Proposed amendment to rule B. 19.1. RECOVERY POINTS

Proposed by A Reaney P&D membership secretary

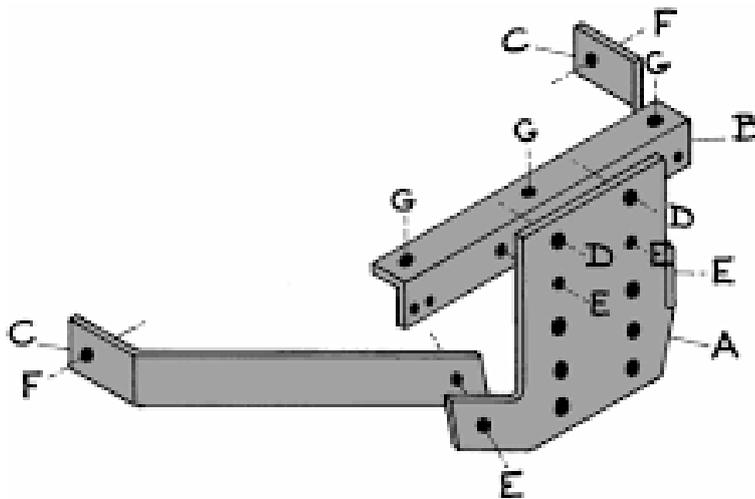
If the recovery point is bolted to a 6mm thick winch bumper or an 8mm thick drop plate does it really need a 3mm spreader behind it?

Diagram A

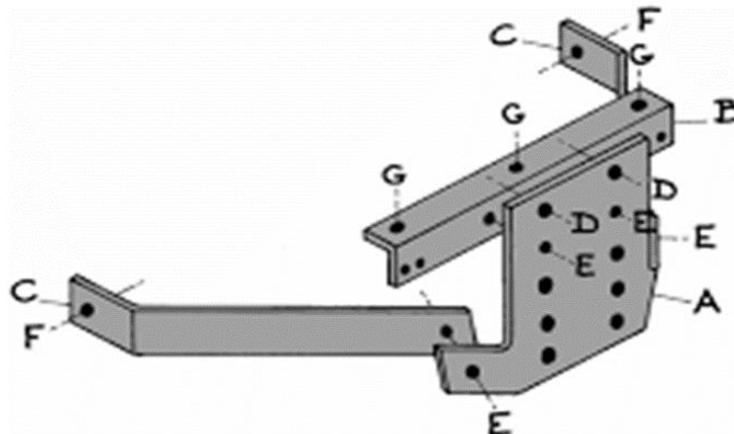
The manufacturers design is for the tow bracket to be secured to multiple fixing points (points G, D and F in the diagram below), 7 bolts in total screwed into existing captive threads. This offers far greater strength than a standard series cross member with 2 x m16 bolts, bolted directly through the cross member even with a 3mm spreader plate on the reverse as that is still dependant on the structural integrity of the cross member and is reliant on the < 3mm steel that the cross member is made from. As opposed to the late Defender design which has the additional support from the stays attached to the fuel tank frame and the vertical bolts attached to the bottom face of the cross member.

“On later style cross members where it is not possible to fit a spreader plate (such as late Defenders cross members with captive nuts) then any recovery point must attach using a minimum of the 7 designated fixing points (D,G,F. Diagram A) using high tensile bolts. Point F should attach to the designated points on the fuel tank frame or if not present can bolt through the longitudinal chassis rails or to suitable brackets attached to these.

Points “E” must be bolted together with high tensile nuts and bolts as per the manufacturers design. The towing attachment must **Not** be attached at point D. Tow attachments must be fitted using high tensile M16 bolts and nuts or equivalent. Drop plates / recovery systems can be shortened or purpose built provided they attach to the vehicle by the same 7 bolt method and are of equal or greater strength and design”.
